CONCEPT SITE PLAN OVERLAY - NOT FOR CONSTRUCTION - NOT A SURVEY

OPTION 1 - PLAN MIRRORED (GARAGE ON WEST, DRIVEWAY SIDE); HOUSE PARALLEL WITH SIDE LOT LINES

40'x45' main body rotated 6.3 deg clockwise from the sheet vertical (mean bearing of the side lot lines), centred between the 15' side setback lines with its rear wall on the rear setback line. Recommended orientation and side - see notes.
Base drawing: PLACES Associates, Inc. Existing Conditions Plan, Project 5827 / Plan 5827-ECP dated Sept. 11, 2026 (1"=10'). House: AFAB Enterprises 'New Single Family Residence' plan set (file "Carter", sheets 1, 3, 4, 5; 1/4"=1'-0"). Overlay prepared 22 Sept. 2026.

LOCATION: 199 CENTRAL STREET

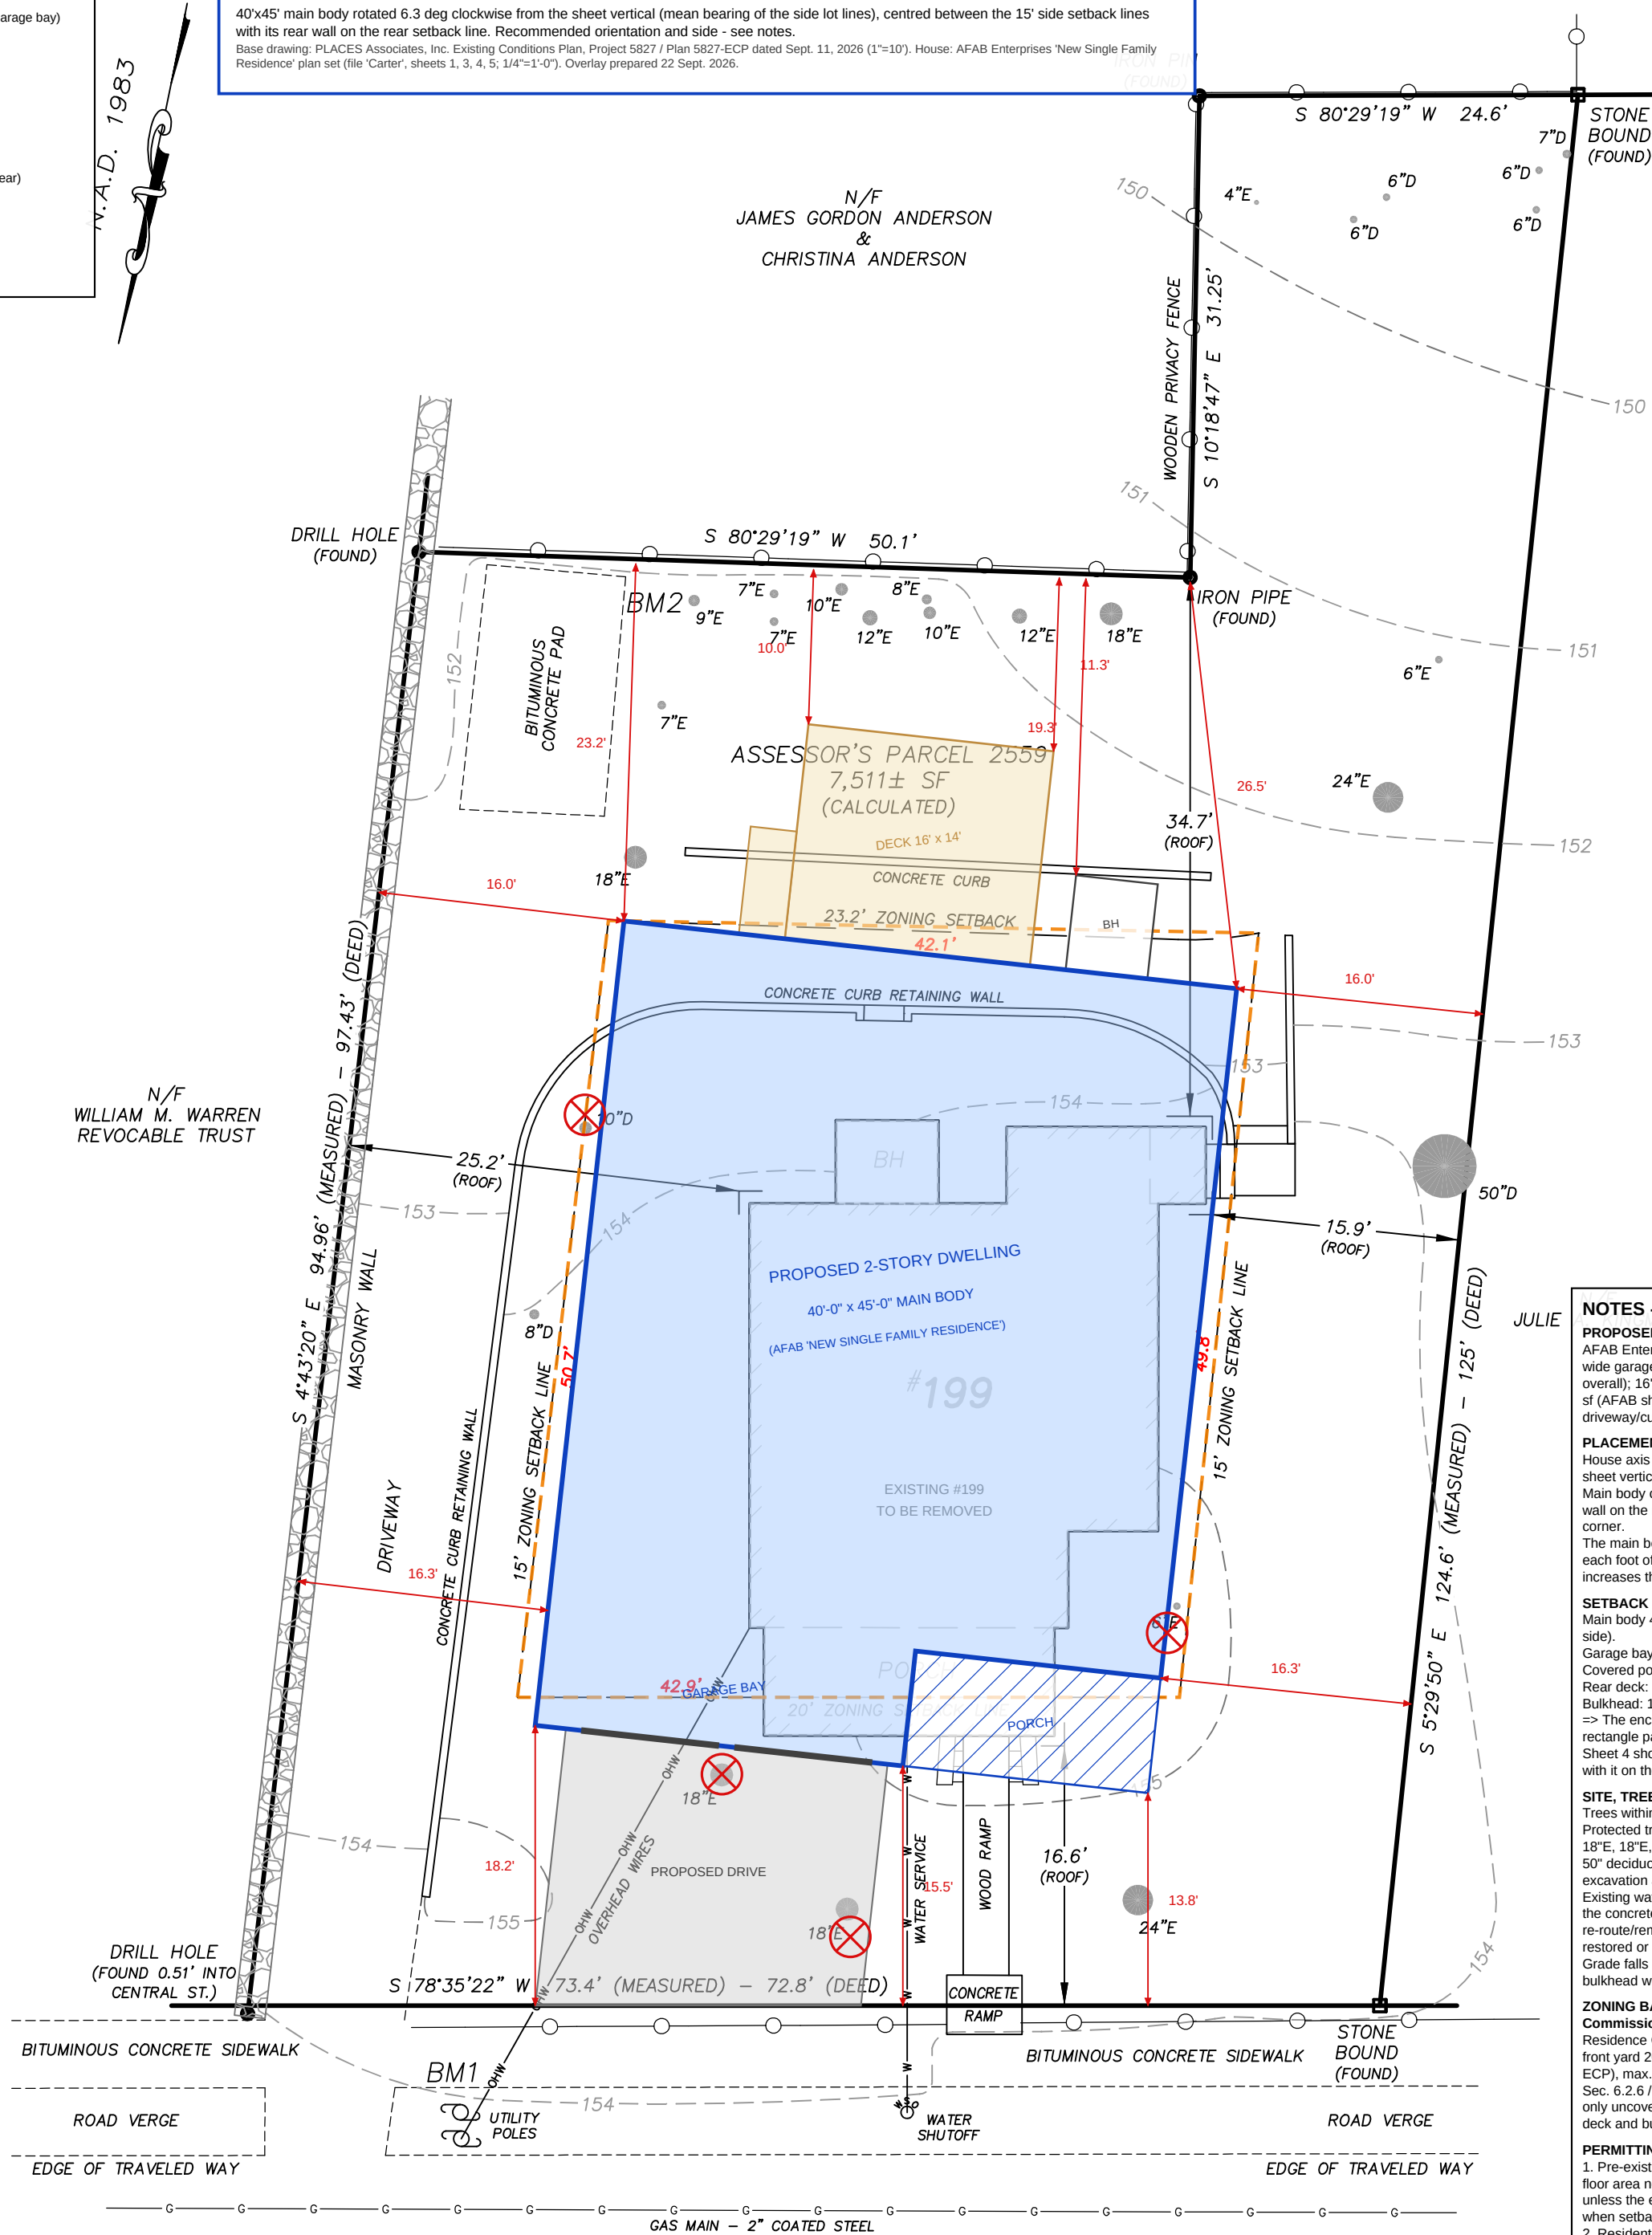
House axis parallel with the mean bearing of the side lot lines: 6.3 deg clockwise from the sheet vertical (west line S 44-43-20 E leans 6.7 deg, east line S 5-29-50 E leans 5.9 deg). Main body centred between the side setback lines (16.0' / 16.0' to the lot lines) with its rear wall on the rear setback line; main-body front wall 21.2' from Central Street at the east corner. The main body can slide only 1.3' toward the street before it reaches the 20' front line; each foot of slide reduces the rear-yard encroachment of the deck/bulkhead by a foot and increases the front-yard encroachment of the garage/porch by a foot.

Main body 40'x45': 21.2' street, 16.0' W, 16.0' E, 23.2' rear - COMPLIES (1.0' spare each side).
Garage bay (WEST): 15.5' to 18.2' from street - 4.5' INSIDE the front setback.
Covered porch (EAST): 13.8' to 15.5' from street - 6.2' INSIDE the front setback.
Rear deck: 10.0' to 11.3' from rear lot line - 13.2' INSIDE the rear setback.
Bulkhead: 19.3' from rear lot line - 3.9' INSIDE the rear setback.
=> The enclosed house as drawn does NOT fit the envelope in any orientation: a 40'-wide rectangle parallel with the lot can be at most ~46.3' deep here, vs. 52'-6" for this plan. Sheet 4 shows the largest front projection that fits (3'-0" with the garage on the west, 1'-3" with it on the east); the memo lists the relief/redesign options.

Trees within 3' of the footprint or drive (marked X): 18"E, 18"E, 6"E, 10"D.
Protected trees (>= 6" DBH in the setback strips, Tree Preservation Bylaw): 50"D, 24"E, 18"E, 18"E, 18"E, 24"E, 10"D, 8"D, 18"E, 12"E.
50" deciduous tree on the east line is ~15' from the nearest proposed structure; keep excavation and the drive out of its root zone (arborist review).
Existing water service (centre of lot), overhead electric from the poles at the SW corner, the concrete-curb retaining wall and the bituminous pad at the rear are all affected - re-route/remove as required. The existing west-side driveway/curb cut can be closed and restored or kept as a parking pad; the new apron needs a CPW driveway permit.
Grade falls ~5' from Central St (el. 155) to the rear line (el. 150-151), so the deck and bulkhead will stand well above grade; AFAB's 'bulkhead size may vary' note applies.

- Pre-existing nonconforming lot: a replacement house over 150% of the existing gross floor area needs a ZBA special permit (Sec. 7.1.5 / 11.6); the 3,387 sf plan is well over that unless the existing house is > 2,258 sf. Precedents show the ZBA routinely grants these when setbacks are met - encroachments (above) weaken the case.

OPTION 2 - PLAN AS DRAWN (GARAGE ON EAST); HOUSE PARALLEL WITH SIDE LOT LINES

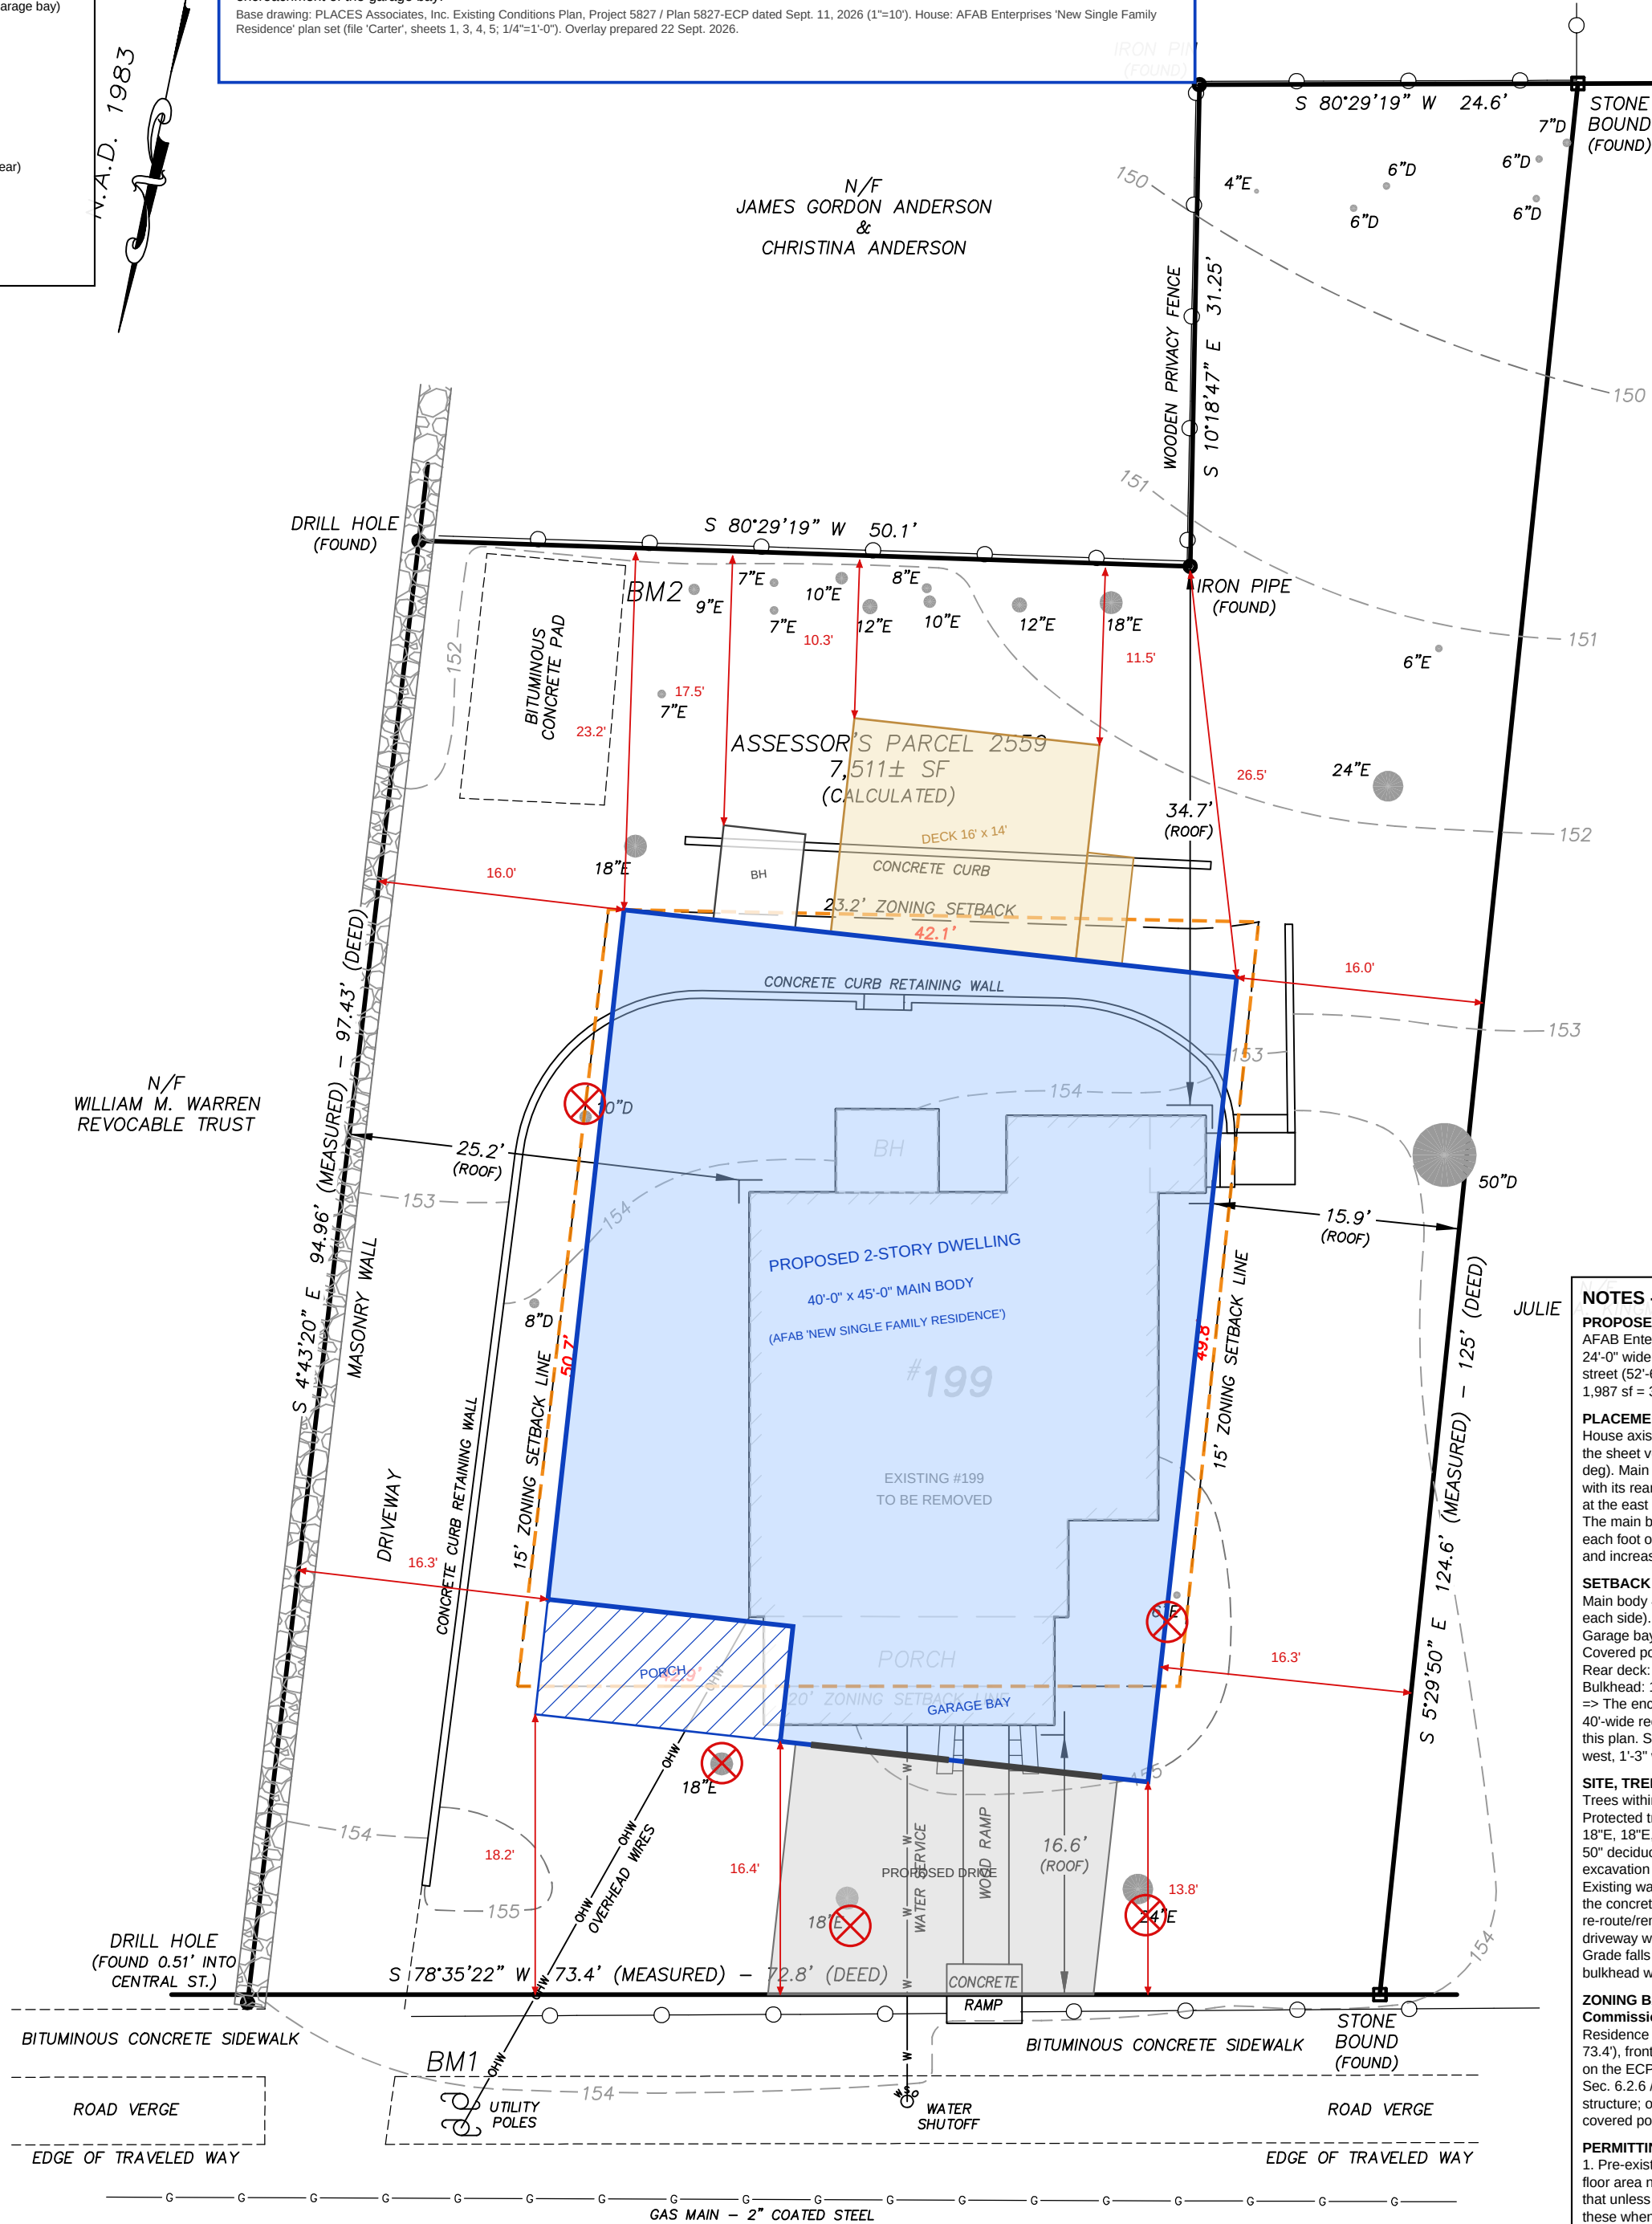
The main body can slide only 1.3' toward the street before it reaches the 20' front line; each foot of slide reduces the rear-yard encroachment of the deck/bulkhead by a foot and increases the front-yard encroachment of the garage/porch by a foot.

Garage bay (EAST): 13.8' to 16.4' from street - 6.2' INSIDE the front setback.

Covered porch (WEST): 16.4' to 18.2' from street - 3.6' INSIDE the front setback.

Rear deck: 10.3' to 11.5' from rear lot line - 12.9' INSIDE the rear setback.

Bulkhead: 17.5' from rear lot line - 5.7' INSIDE the rear setback.

=> The enclosed house as drawn does NOT fit the envelope in any orientation: a 40'-wide rectangle parallel with the lot can be at most -46.3' deep here, vs. 52'-6" for this plan. Sheet 4 shows the largest front projection that fits (3'-0" with the garage on the west, 1'-3" with it on the east); the memo lists the relief/redesign options.

50" deciduous tree on the east line is -15' from the nearest proposed structure; keep excavation and the drive out of its root zone (arborist review).

Existing water service (centre of lot), overhead electric from the poles at the SW corner, the concrete-curb retaining wall and the bituminous pad at the rear are all affected - re-route/remove as required. A new east-side curb cut is needed; the existing west driveway would be abandoned.
